Product Change Notification

Product Group: DIODES / February 3, 2016 / PCN-DD-003-2016 Rev 0

Datasheet correction for product outline in Alloy DO8 product family

FIG 1

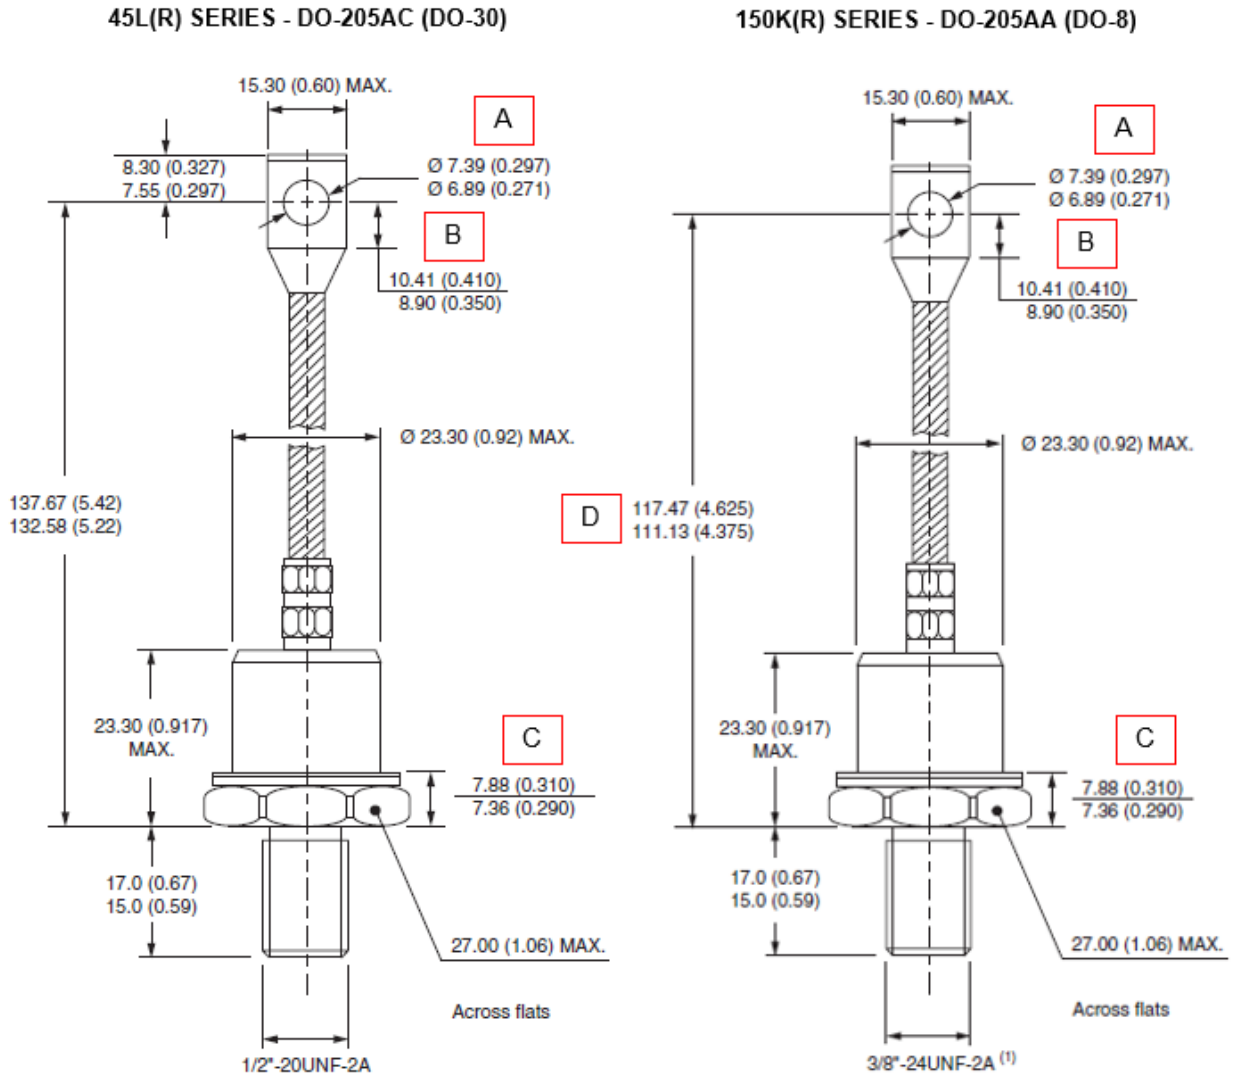
Datasheet product outline correction for Alloy DO8 product family.

See FIG 1, TABLE 1 for details.

DIMENSION REFERENCE	FROM millimeters (inches)		TO millimeters (inches)	
A	6.89 (0.271)	7.39 (0.297)	6.50 (0.255)	7.39 (0.297)
B	8.90 (0.350)	10.41 (0.410)	11.70 (0.460)	17.30 (0.681)
C	7.36 (0.290)	7.88 (0.310)	7.88 (0.310)	8.48 (0.333)
D	111.13 (4.375)	117.47 (4.625)	111.13 (4.375)	124.00 (4.881)
